# Transport Access Program **Glenbrook Station Upgrade** Determination Report

# **Glenbrook Station Upgrade Determination Report**

**Transport Access Program  
Ref 6190170**

**Figure 2: Revised station building layout**

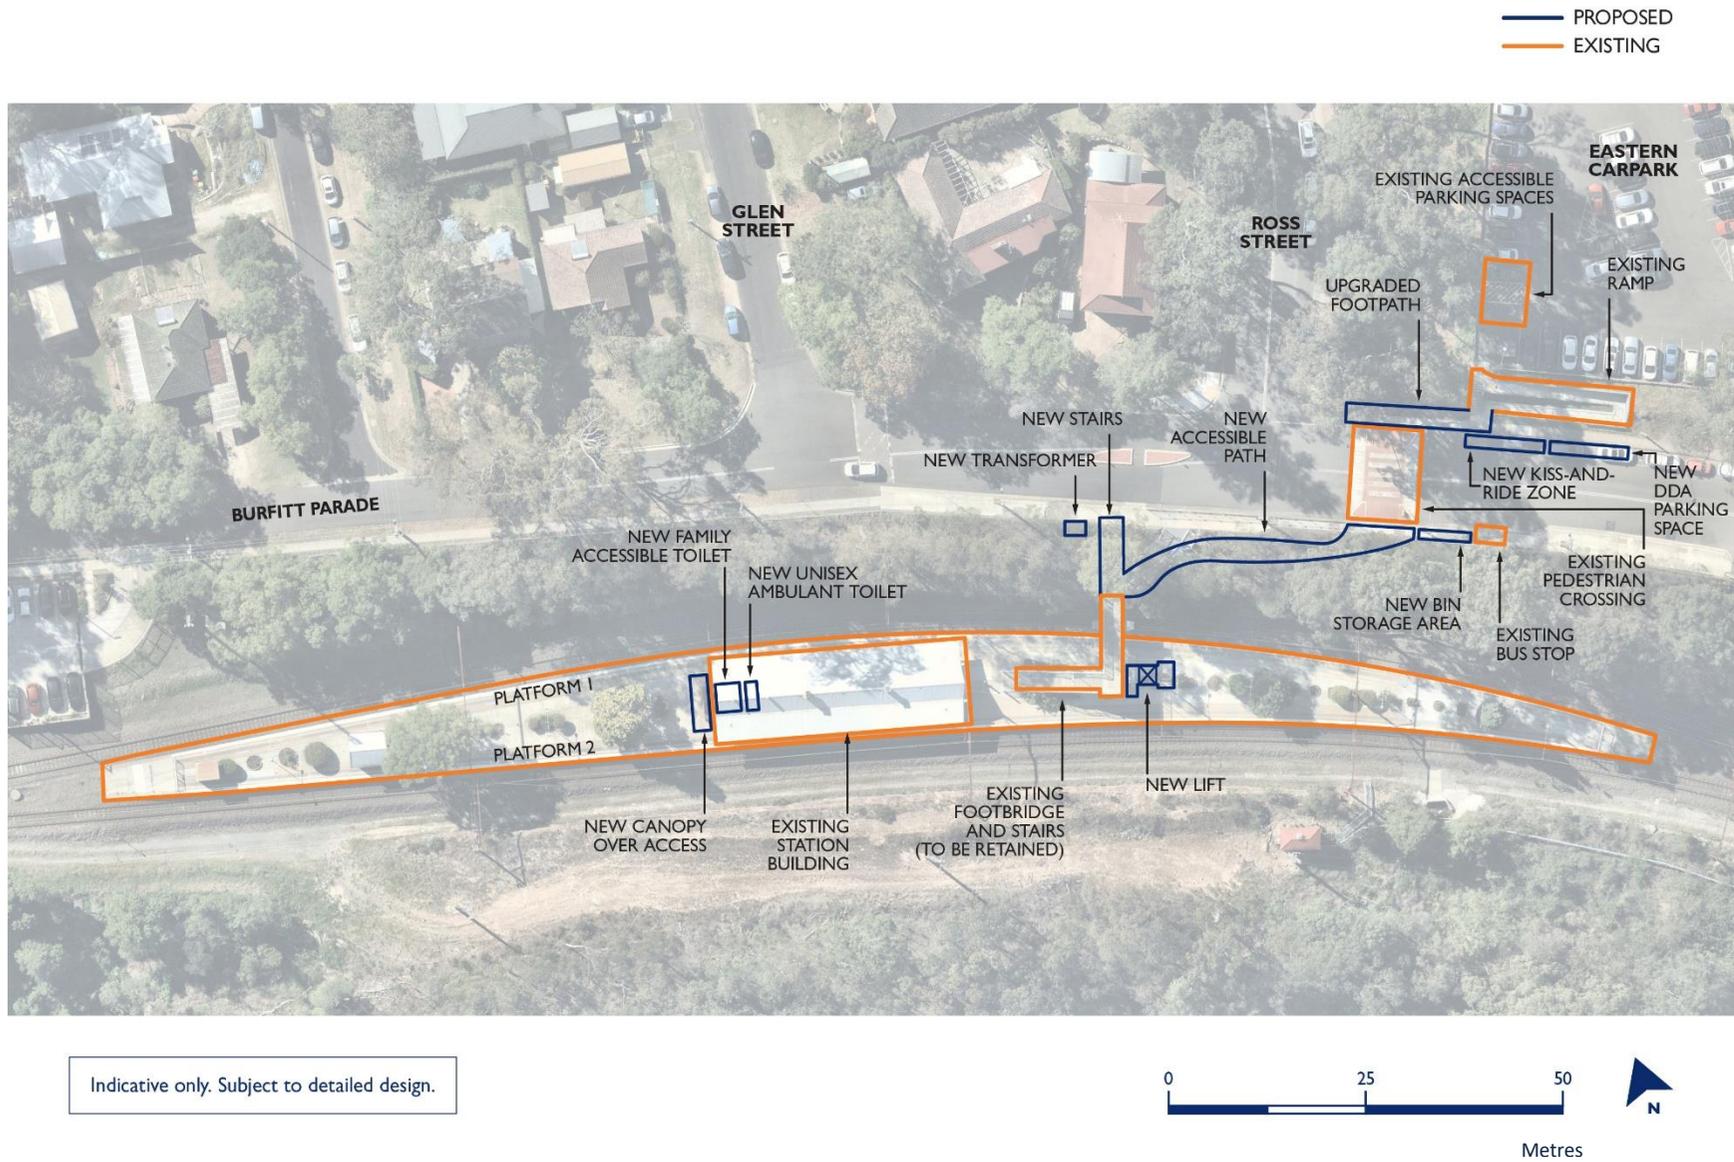
Aspect of the Proposal	Design change	Discussion of impacts
<b>Station building</b>	<p>There would be a reduction in works to the station building (refer to Figure 2):</p> <ul style="list-style-type: none"> <li>proposed works located within the 'comms/staff amenities' and 'staff room' are no longer required as existing equipment racks will be utilised to house equipment</li> <li>proposed door widening of the Family Accessible Toilet is not required, and the existing grill will be removed and replaced with a new solid door</li> <li>a modern steel bookcase would be removed from the 'store' building.</li> </ul>	<p>The changes relate to potential heritage impacts and a heritage assessment has been completed by RPS (refer to Appendix F). The heritage assessment found that overall, the changes represent a reduction in impacts to heritage values (through avoiding direct impacts to heritage fabric) and amendments to the mitigation measures recommended in the Glenbrook Statement of Heritage Impact (RPS, 2018b). Consideration for the revised mitigation measures has been included in Conditions of Approval 23 and 24.</p>
